REQUEST FOR INFORMATION

RFI NUMBER	NL-	NL-RFI-038		
ISSUE DATE (YY/MM/DD)	March 21, 2011			
PRIORITY	H M X L			
REQ'D RESPONSE DATE	March 25, 2011

REQ'D R	ESPONSE DATE	March 25, 2011
Hope Bay Mining Project					4
Subject:	Doris North Land Farm Stake-	Out Table	Project Zone/	'Area:	Doris North
Company:	Nuna Logistics Ltd. (Nuna)		Station/Location:		Doris North Land Farm
Attention:	Doug Fielding/Jerry Graham		Discipline:		Civil
					_
AFE:			Specification	Number:	
Related Drawings:	SRK Doris North Land Farm IFC Package		Related Documents:		Revised Land Farm Stake-Out Tables (attached)
Related WBS Code		WBS Code	Description:

For 6" foundation crush surface

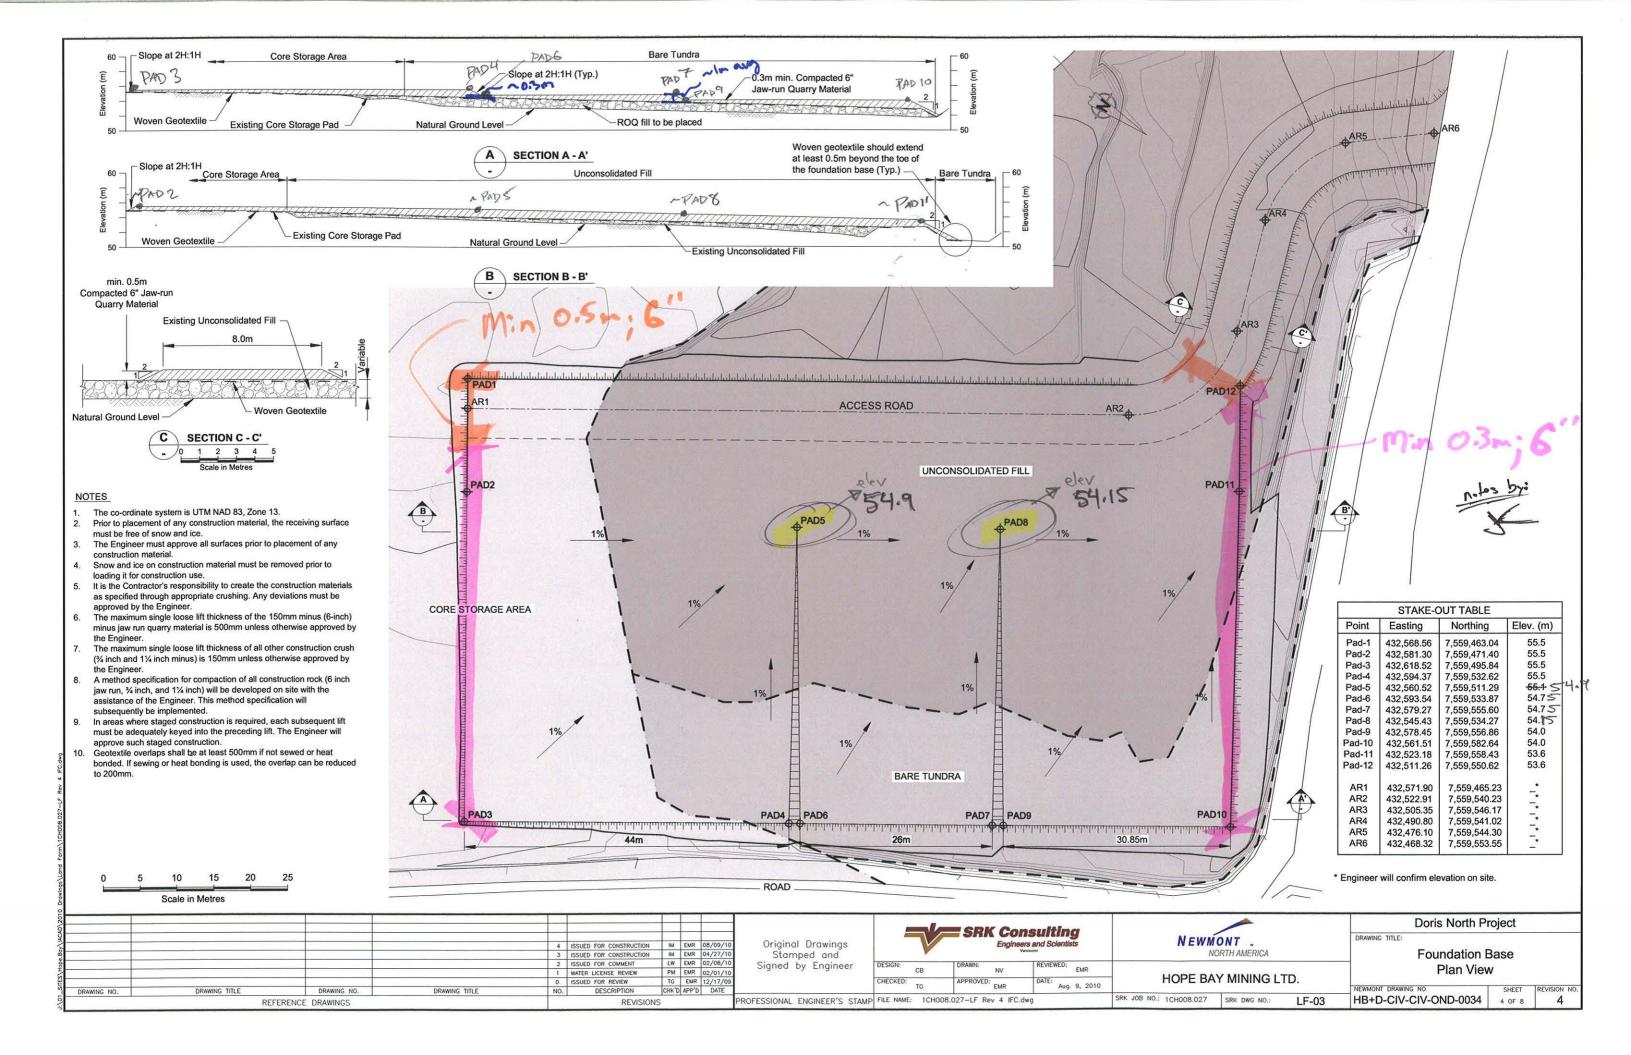
•	cription of Issue/Approval Requi				
					e-Out table within the attached
document supersedes the	Stake-out tables in SRK's Doris	North Land Fa	rm IFC Package	Revision 4.	
Proposed Corrective Actio	n:				
	ovides formal confirmation on t	he above topi	c.		
Autha requests that SKK provides formal commitmation on the above topic.					
Originator: Niko Heir M-/ // // // // // // // // // // // // /					
Originator.		[When	1pm		March/21/11
	Print: Sign: Date: (
Cost Impact				2011 Nuna Construct	
Detailed Estimate attached	d ⊠No □Yes De	etailed estimat	te will be prepar	ed following IFC revis	ion
Schedule Impact	⊠No □Yes				
Source for Communication	Owner Change	\boxtimes	Clarification/Info	Cons	structor Change
	☐ Vendor Change		Designer Change	Othe	er
Note: RFI's are not authorized change documents and cannot be used to direct a change in contract requirements. If Newmont's response on					
the RFI has cost and/or schedule effect, it is the contractor's responsibility to immediately advise Newmont. Work undertaken without

I'm trying to stake the ROQ for the Landfarm foundation base (I'm looking at LF-03 REV 4, sheet 4/5). All I have for stake out points is the 6" surface but according to cross section B the ROQ is a straight grade and the 6" has three different benches so I can't simply drop the 6" to get ROQ. Please advise on how to go about staking the ROQ surface.

Newmont written authorization is at the contractor's risk and expense					
Corrective Action Approved Correct as Follows:					
Response:					
On August 30th, 2010 Nuna Survey requested additional clarification upon review of the 3D model. Minor discrepancies were noted and updated survey stakeout points were provided [Attachment 1]. The stakeout points outlined in NL-RFI-038 supersede the stakeout points on IFC drawing LF-03 Rev 04. A Rev 05 of this drawing will be issued.					
				,)

Please find the attached pdf which details revised stakeout points to follow when laying out the Landfarm foundation base. I have included two tables, one details the stakeout points for the ROQ surface and one detailing the stakeout points for the 6" surface (the stake out tables have also been pasted below).

Note that two points for the 6" (PAD5 and PAD8) have been revised (from the original IFC drawing) to better match our 3D design model. Please let me know if you have any questions or require any additional information. Thanks for your efforts. Hope you have a great night.
